SERVICE LETTER

No. 556A

Piper Aircraft Corporation

Subject: Turbocharger Waste Gate Return Spring

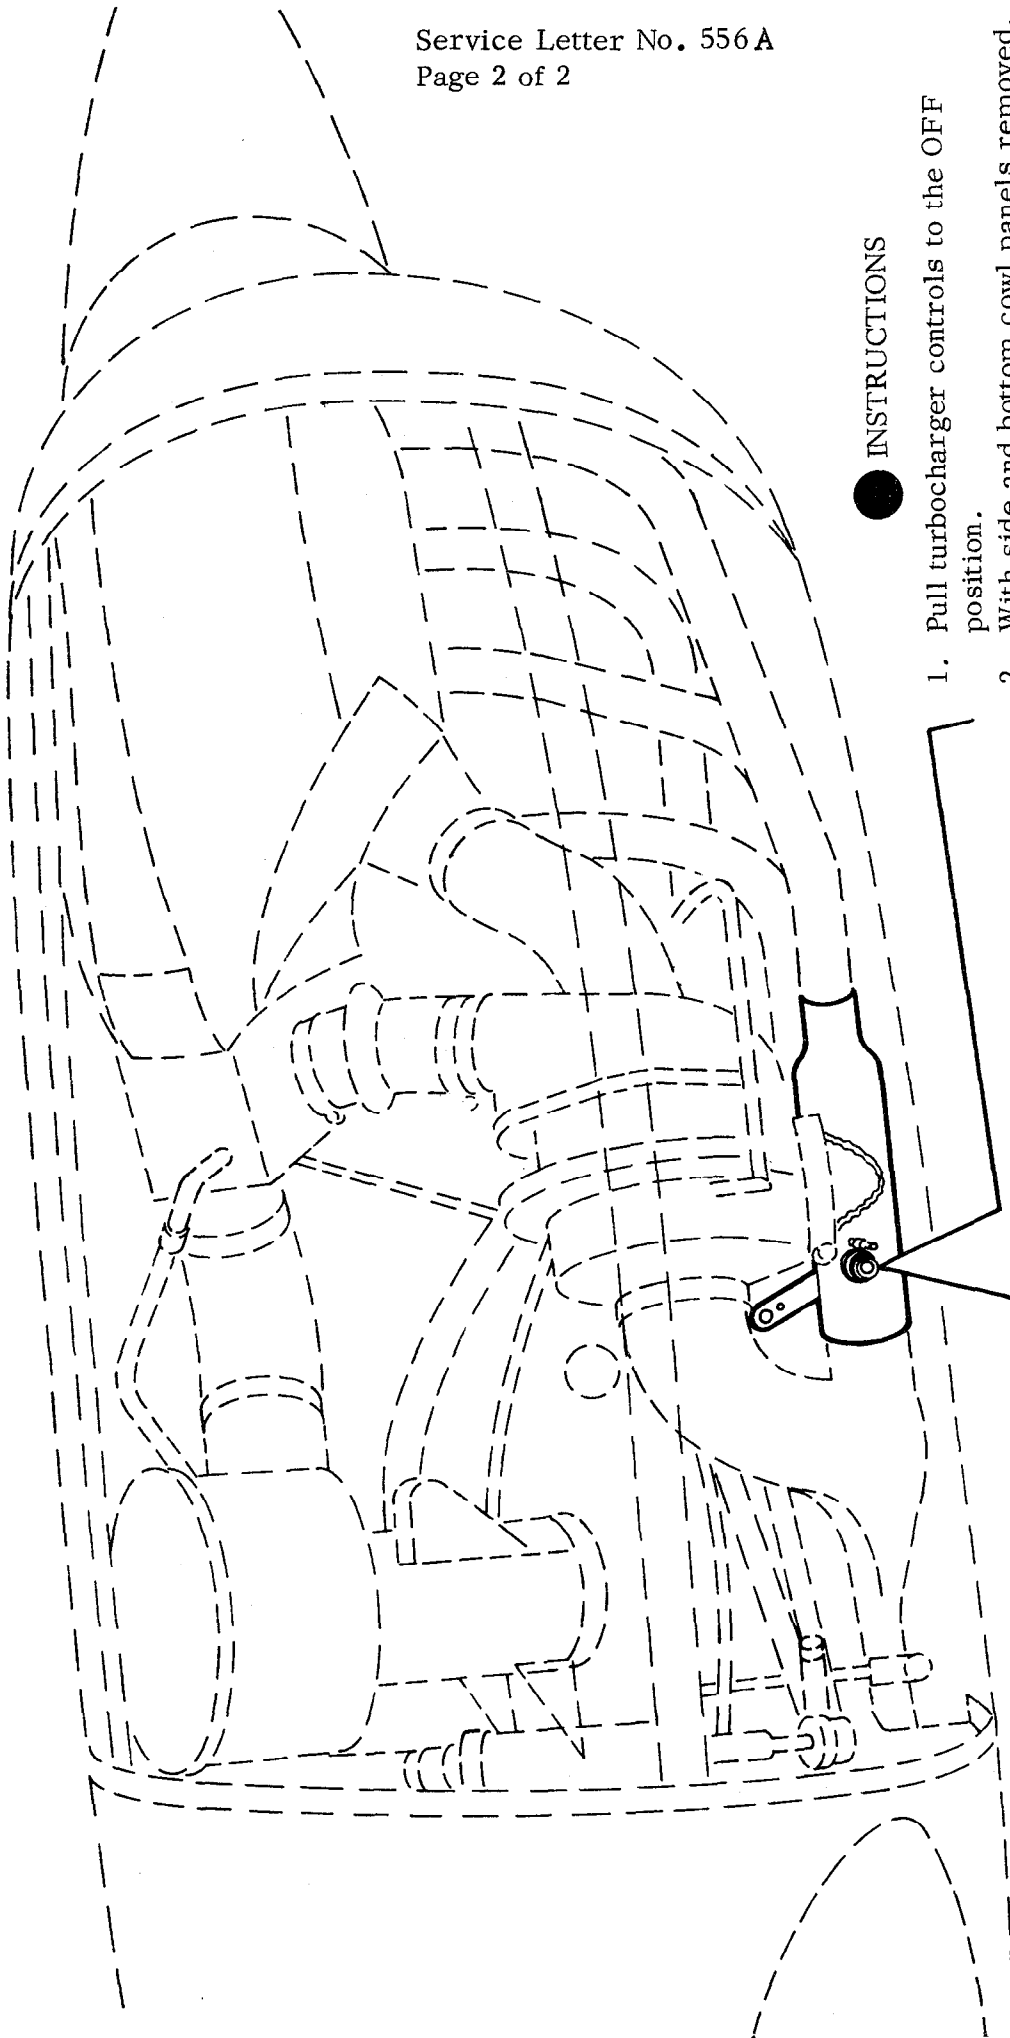
Purpose: To replace the existing turbocharger waste gate return spring with a new heavy duty return spring.

Instructions: Replace the existing waste gate return spring with new waste gate return spring, Rajay part number RJ 4120-11, refer to sketch on reverse side of this letter for installation instructions.

1. Pull turbocharger controls to the OFF position.
2. With side and bottom cowl panels removed, remove the existing turbocharger waste gate spring.
3. Install new turbocharger waste gate spring, Rajay Part Number RJ4120-11, being careful to install center tang in hole 180° to hole from which old spring was removed.
4. Place turbocharger waste gate spring on spring retainer as shown.
5. Actuate turbocharger controls to determine spring winds and unwinds freely.
6. Reinstall cowlings.
